UNITED STATES PATENT AND TRADEMARK OFFICE

APPLICATION NO.	FILING DATE	FIRST NAMED INVENTOR	ATTORNEY DOCKET NO.	CONFIRMATION NO.
10/738,328	12/17/2003	Markus Hartmann	DT-6720	7915

Office Action Summary	Application No. 10/738,328	Applicant(s) HARTMANN, MARKUS	
	Examiner Phong H. Nguyen	Art Unit 3724

DETAILED ACTION

FIG. 2

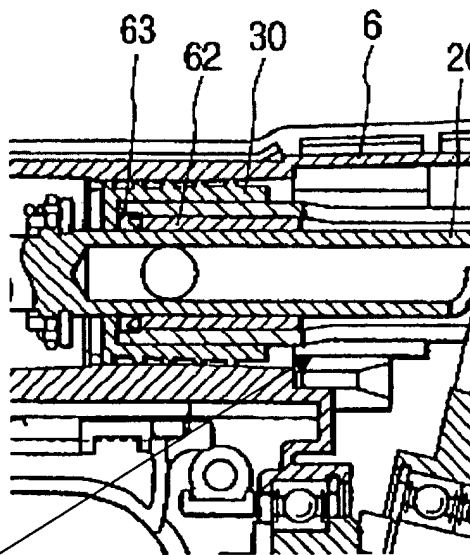
1992). In this case, the groove prevents the bearing sliding along the housing. Applicant further argues that adding a groove will not add any benefit. Providing a groove prevents the bearing contacting other parts in the saw assembly. Repeatedly contacting between the bearing and the other parts in the saw assembly may reduce the useful life of the saw. Providing a groove does not affect the swinging movement of the bolt 12 since it is made of a resilient material.

Bearing 30 may contact this part of the saw during its reciprocating movement.
